PROJECT : LI5
Quanta Computer Inc.

**Quanta Computer Inc.**
PROJECT : LIMA5B

LI□A5B Schematic EC Tracking Record A to B version(SDV/FVT Planar)

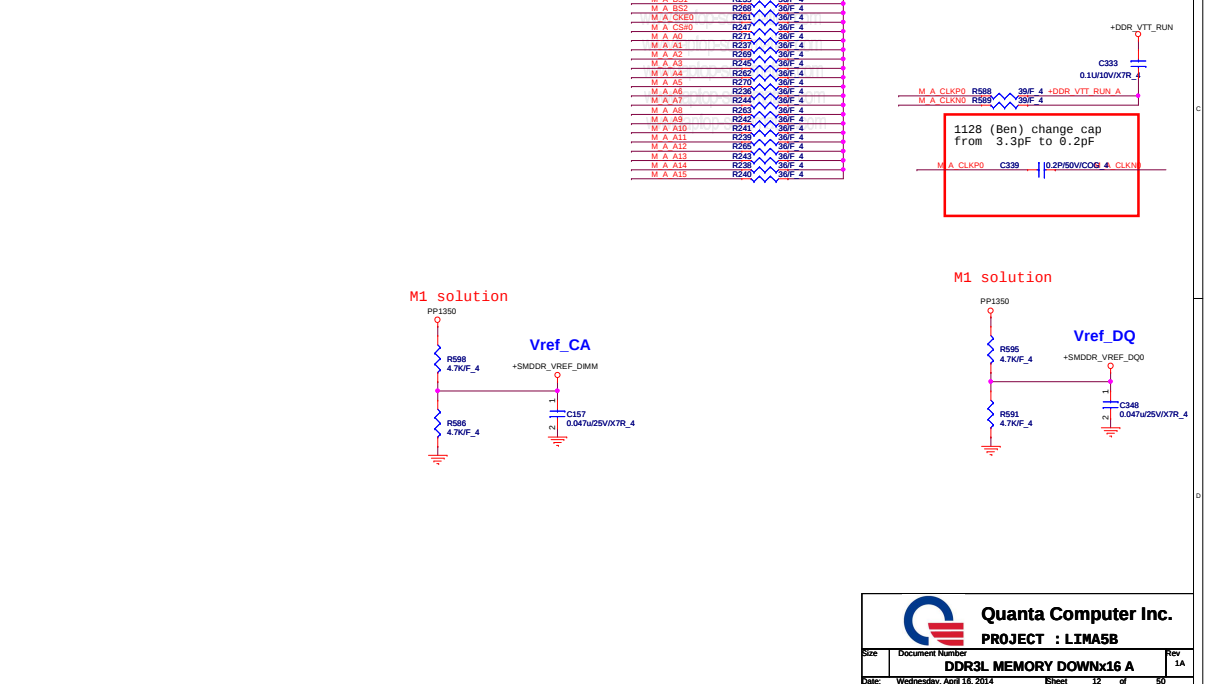
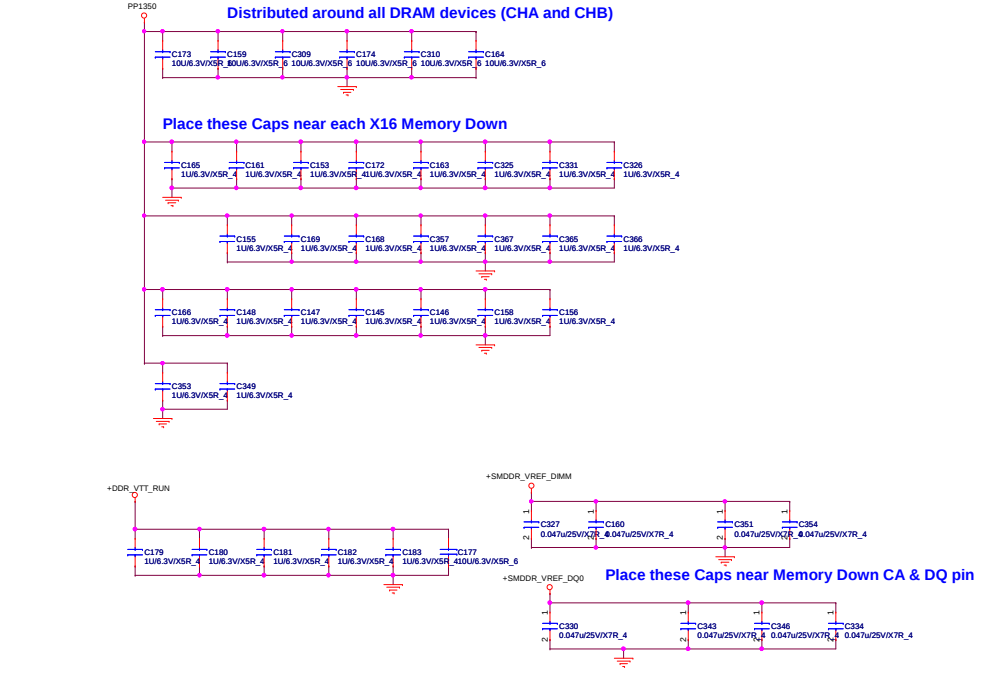
1024 change ODT PU to VTT by Intel request

1128 (Ben) change cap from 3.3pF to 0.2pF

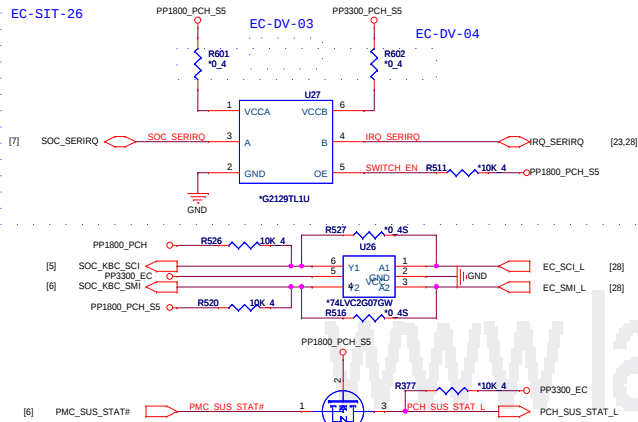
9/6 EC table says SERIRQ is OD pin,
reserve for debugging

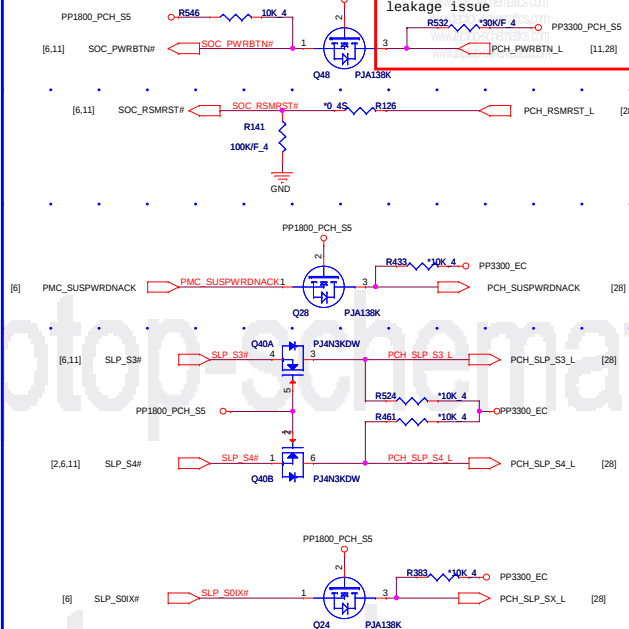
1022 un-stuff R182 for S5
leakage issue

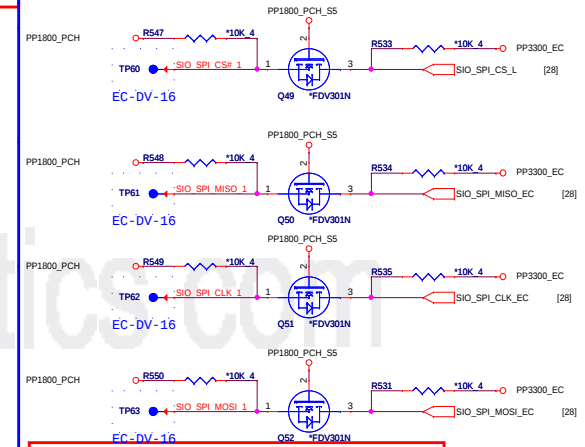
9/6 Need check MOSFET switching
speed>15MHz

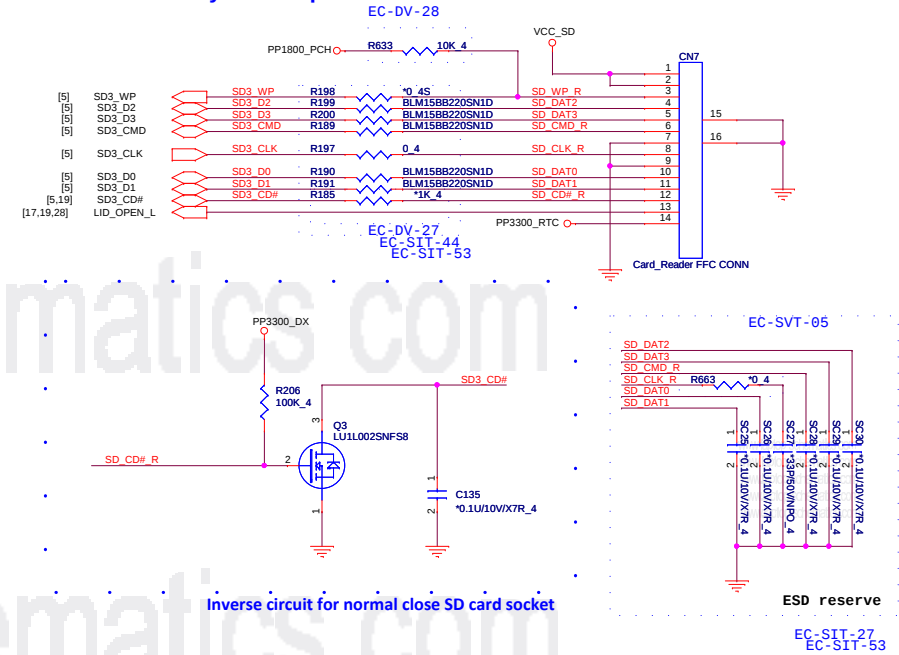
1025 the damping of SDIO change to 0 ohm by Intel request

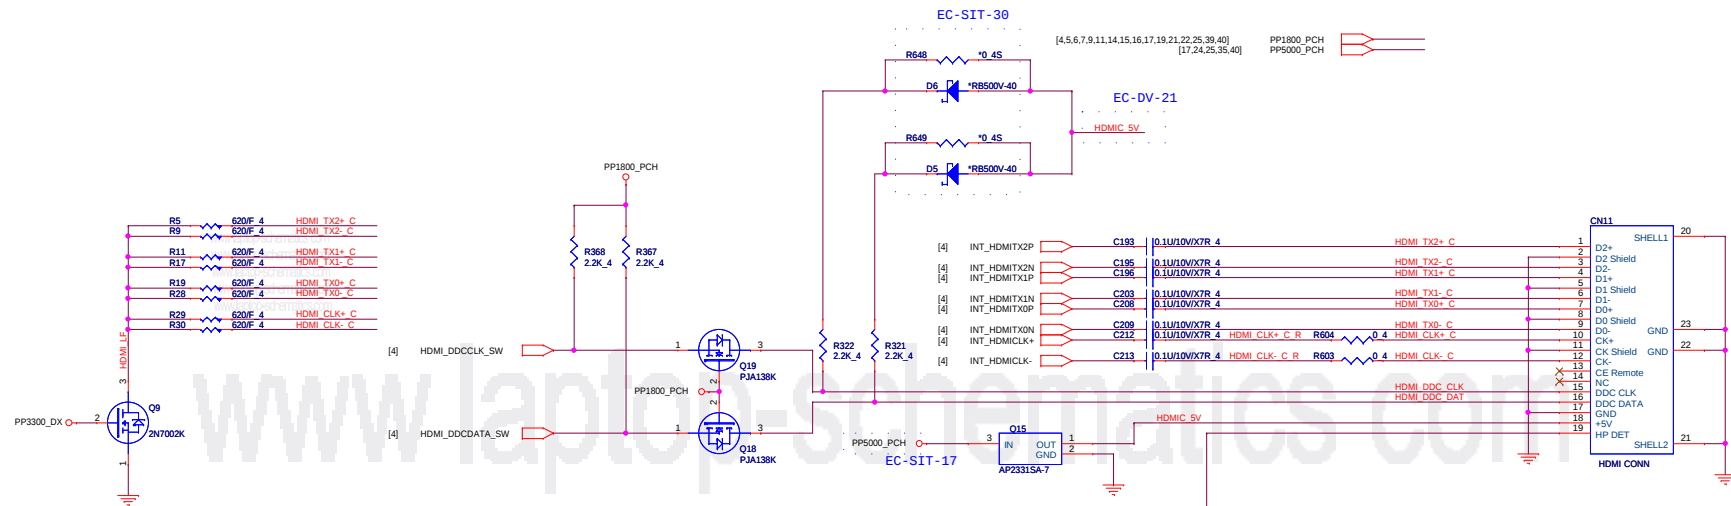
9/6 using optional instead of level shifted, default is from SoC

EMMC (CBS)

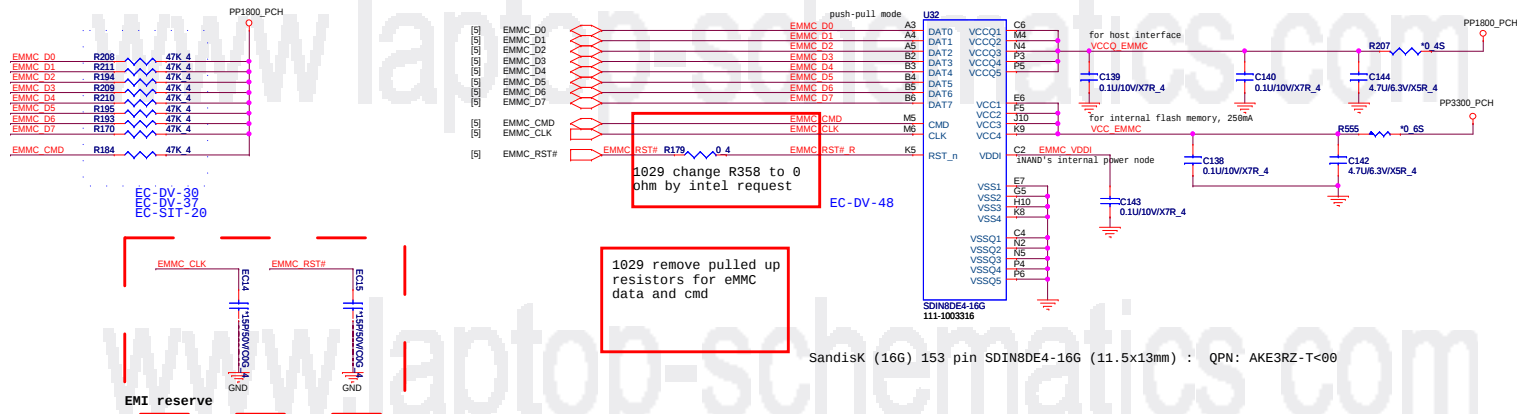
Add pulled up resistors for sandisk debugging

HOLELESS RESET
2-CHIP(KBC)

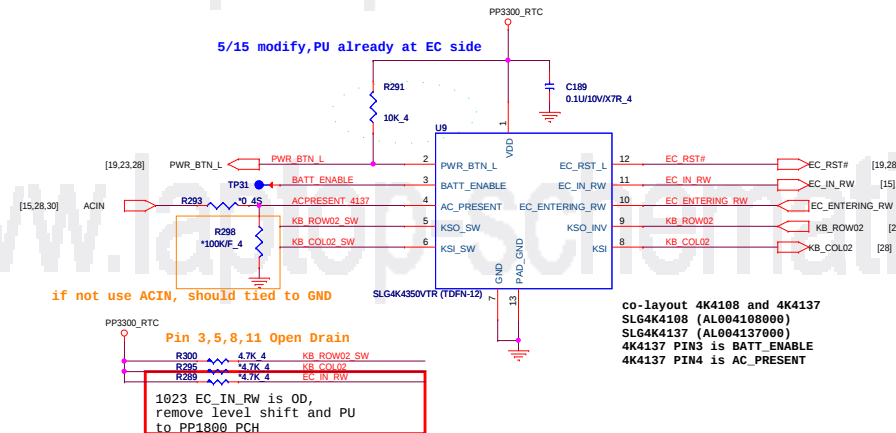
5/15 modify, PU already at EC side
